SUBJECT: **Request for Permit Modification of CAMA Major Development Permit** for the Proposed Replacement of the Lindsay C. Warren Bridge (Tyrrell County Bridge No. 7) on U.S. 64 over the Alligator River/Atlantic Intracoastal Waterway in Tyrrell and Dare Counties, North Carolina. STIP Project No. HB-0001; Federal Aid Project No. NHPB-0001.

REFERENCE: CAMA Major Development Permit, Permit No. 136-23. Issued November 30, 2023.

The purpose of this letter is to request modification of the existing CAMA Major Development Permit to include these activities. In addition to this letter, revised permit drawings showing test pile locations and impacts, mapping and a construction detail of mooring pile locations, and a construction detail of test piles are also included.

Bent #91 Test Pile
Sta. 167+32.00

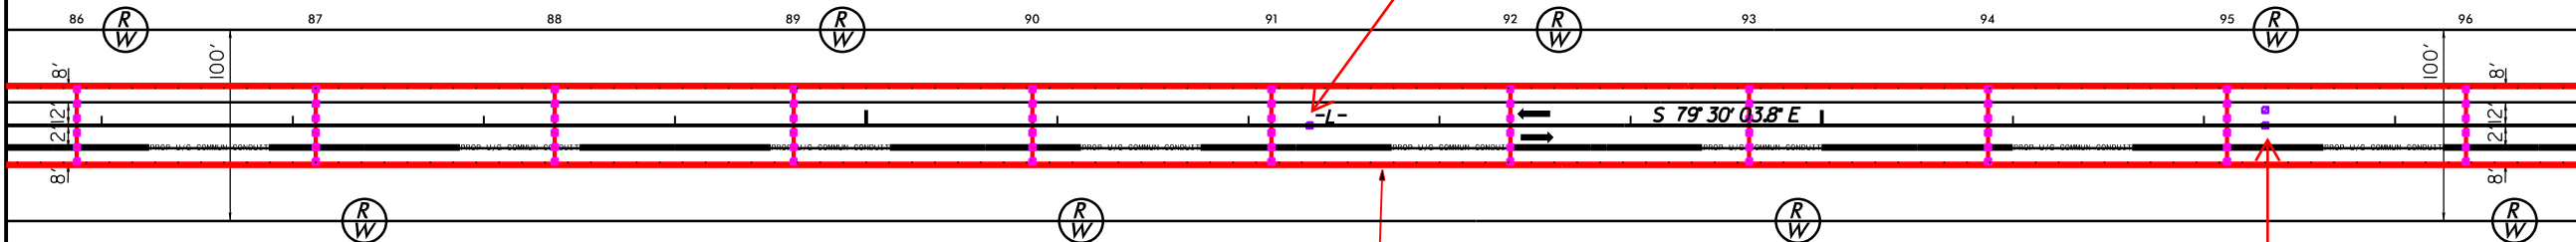
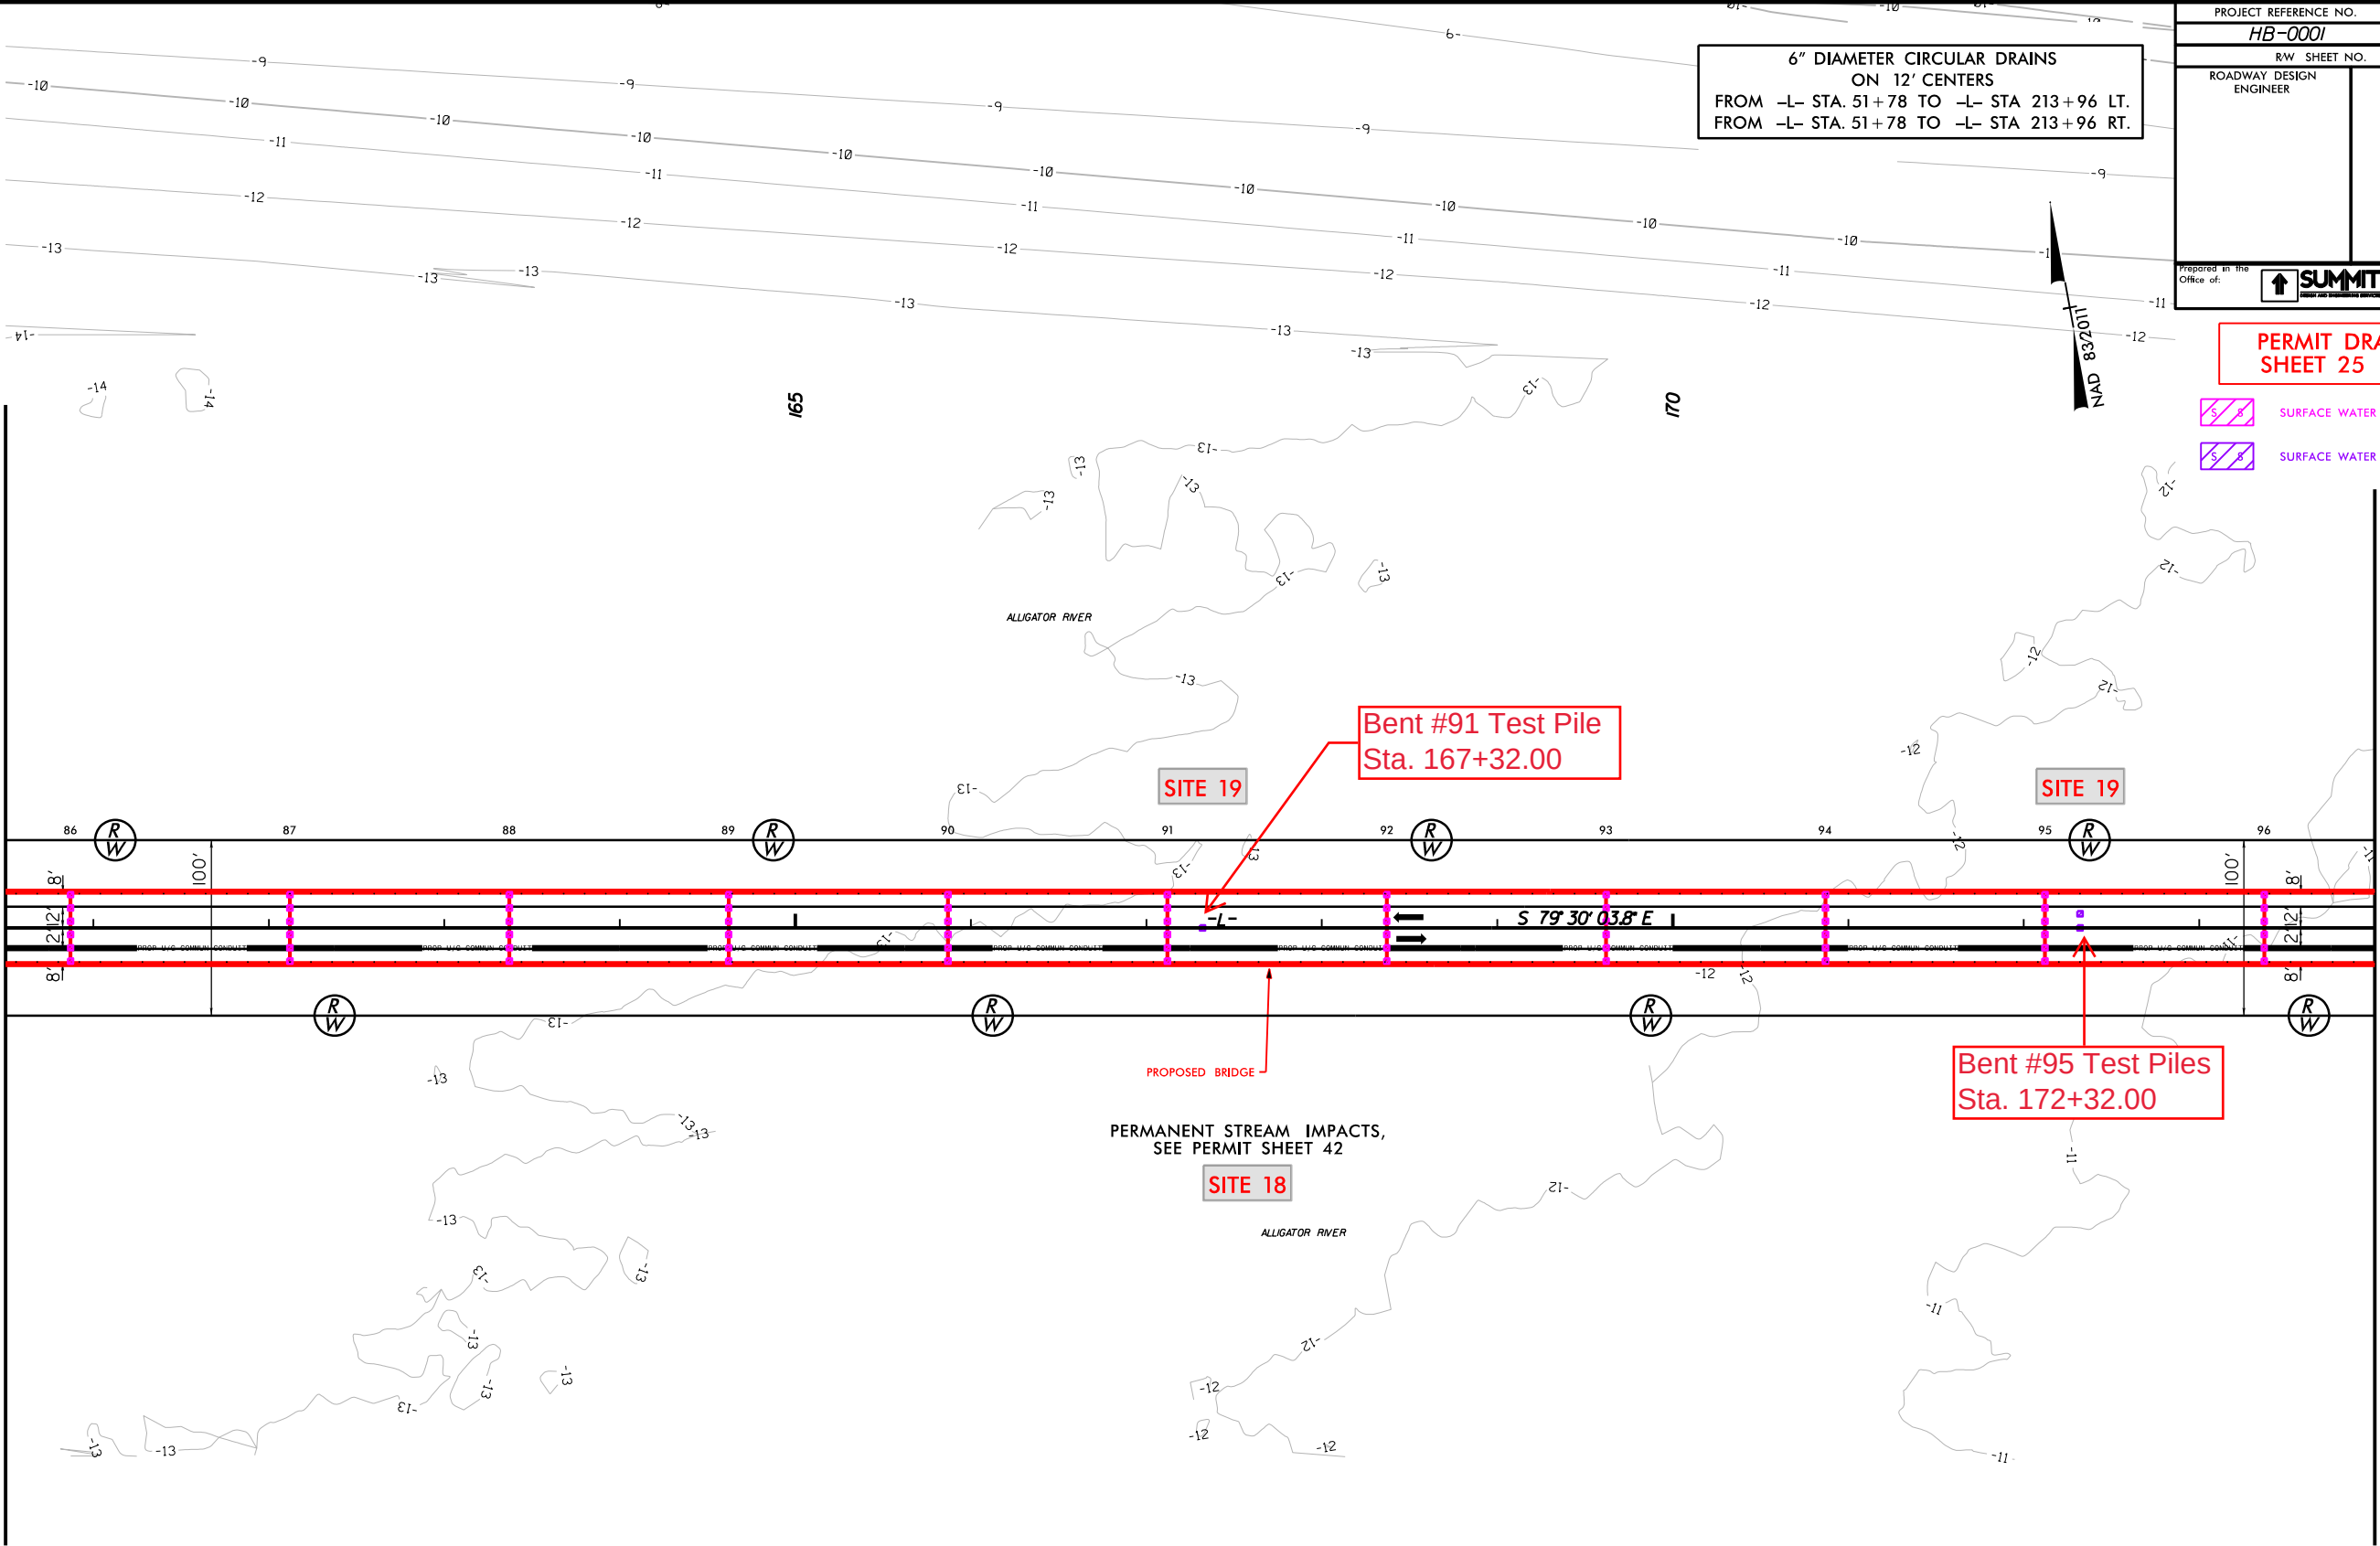
- **Bent 62:** 1 ea. 36" Pile Station 131+07 @ CL
- **Bent 66:** 1 ea. 36" Pile Station 136+07 @ CL
- **Bent 73:** 1 ea. 36" Pile Station 144+82 @ CL
- **Bent 91:** 1 ea. 36" Pile Station 167+32 @ CL

- **Bent 95:** 1 ea. 36" Pile Station 172+32 @ CL
1 ea. 36" Pile Station 172+32 @ 8' LT of CL
- **Bent 100:** 1 ea. 36" Pile Station 177+32 @ CL
- **Bent 102:** 1 ea. 36" Pile Station 181+07 @ CL

Test Pile Detail

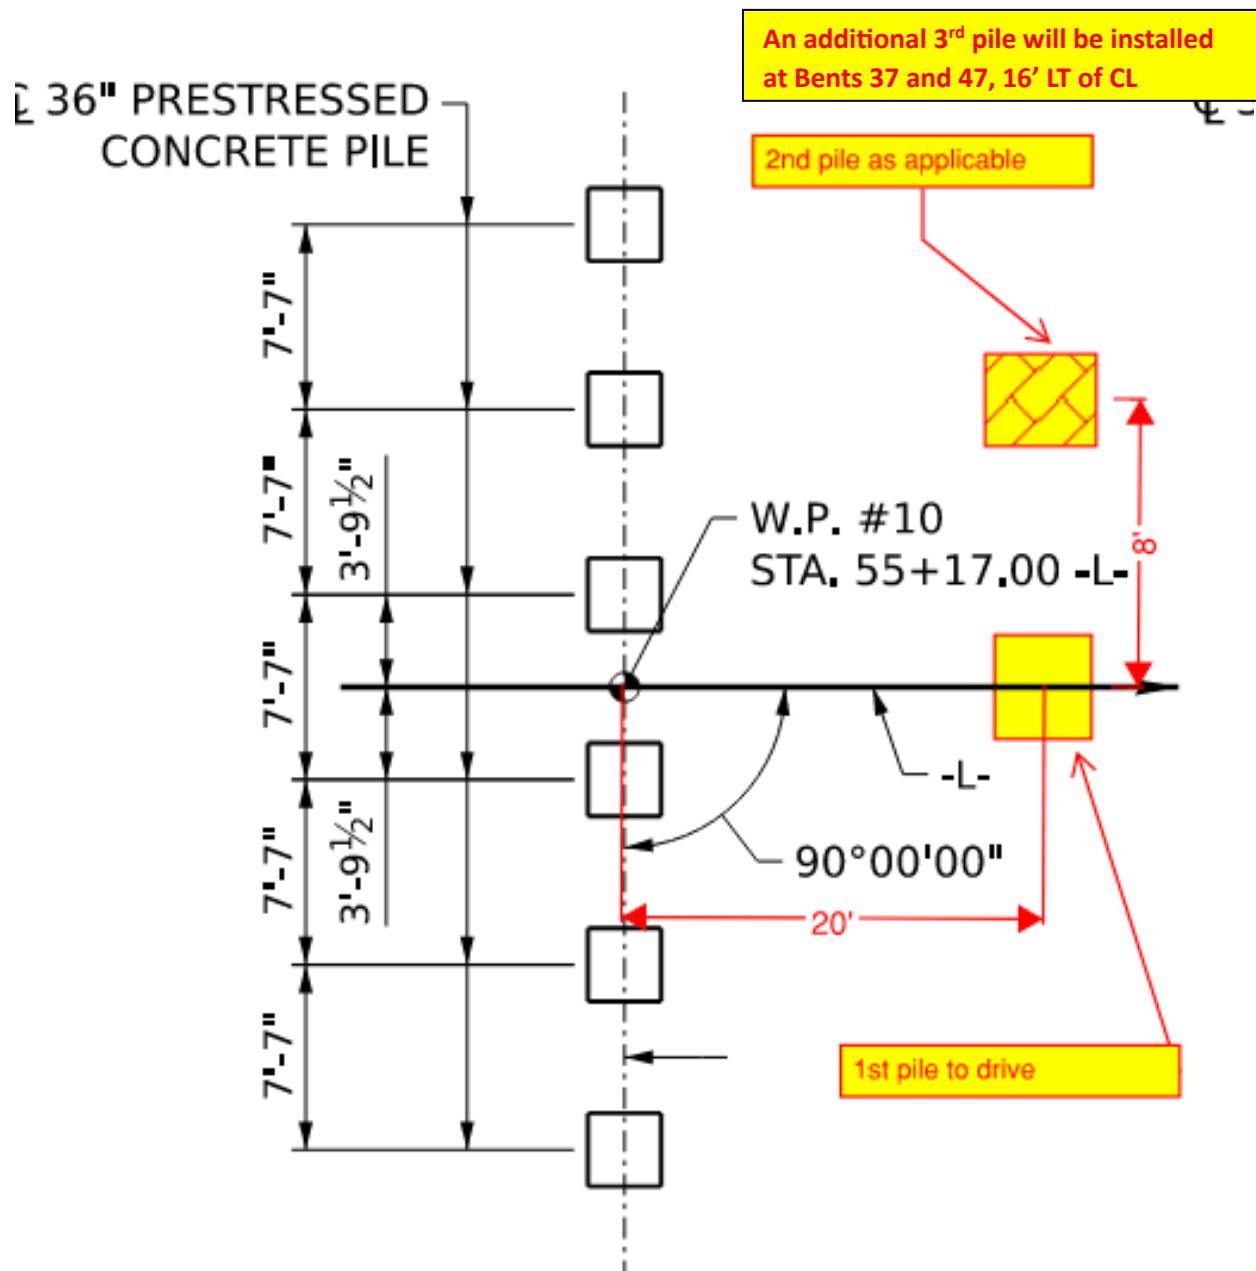
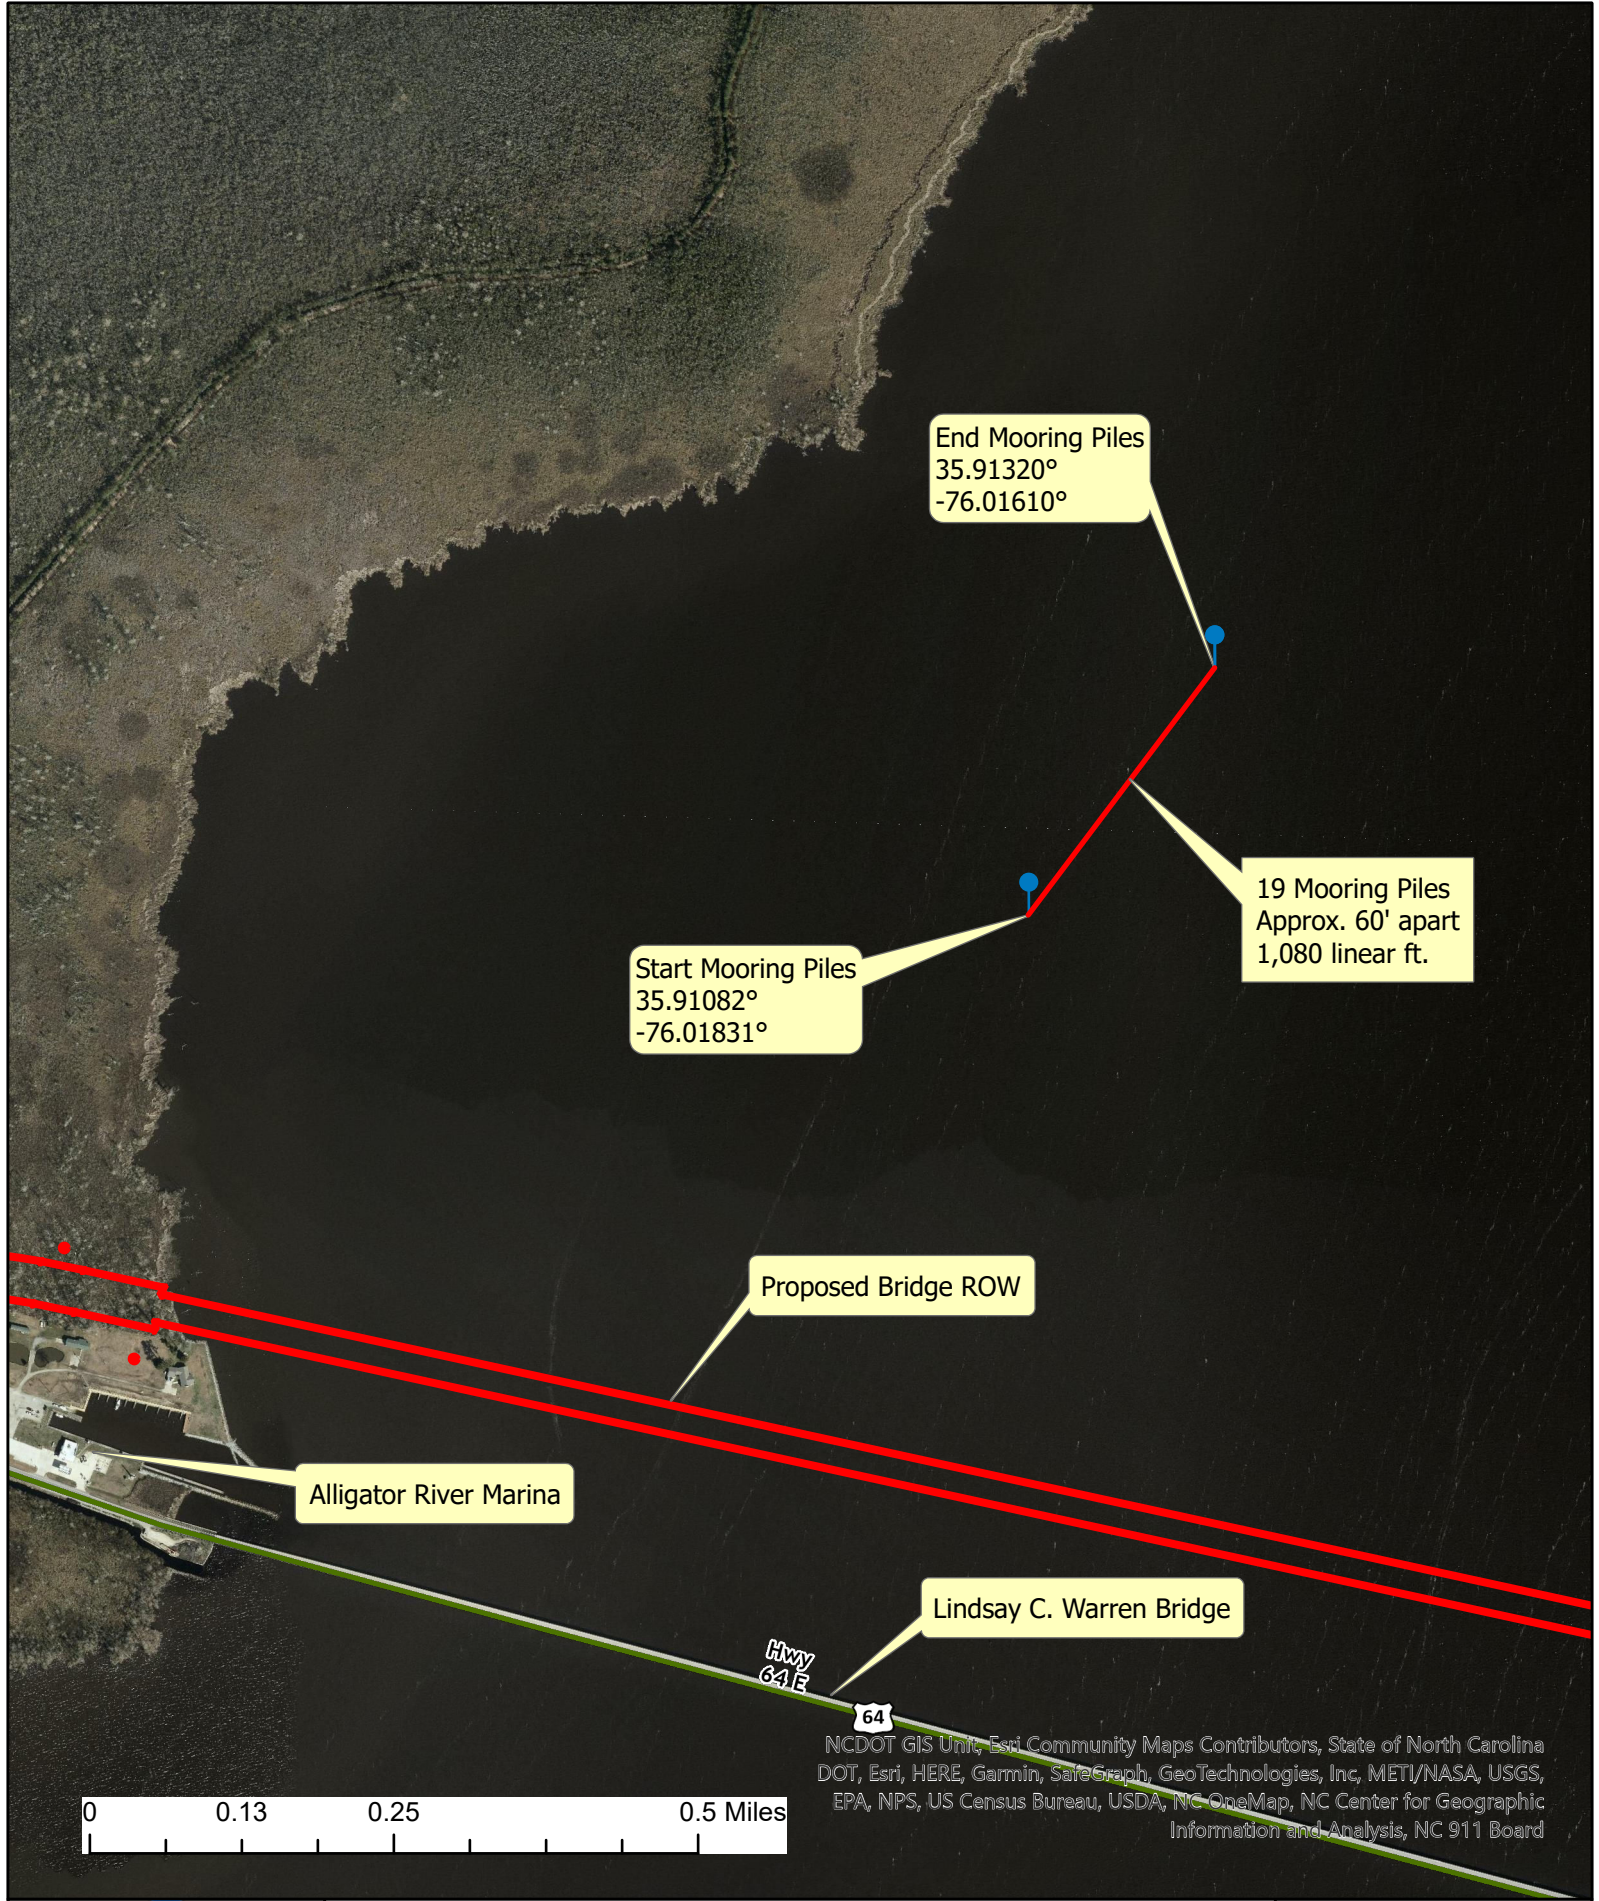
Test piles will be driven at 15 locations and will consist of either 36-inch square precast concrete piles (listed as 36" Pile below) or a combination of 36-inch concrete piles and 48-inch steel pipe piles (listed as 48" P-Pile below). The test piles being installed at each location are listed below; proposed pile installation locations are both listed below and shown on the attached detail. Some piles would be driven within a temporary 60-inch steel casing; test piles driven in casings will be selected based on pile driving data collected during the operation. Due to the upcoming in-water work moratorium (from July 15 – September 30 for the entire river; February 15 – June 30 for the deepwater channel), the test piles at Bent 47 will be driven first. A variety of diesel and hydraulic hammers will be assessed during the program.

Test piles will be cut below mudline after use. The test piles will result in an increase in **permanent surface water impacts of 0.004 acres.**
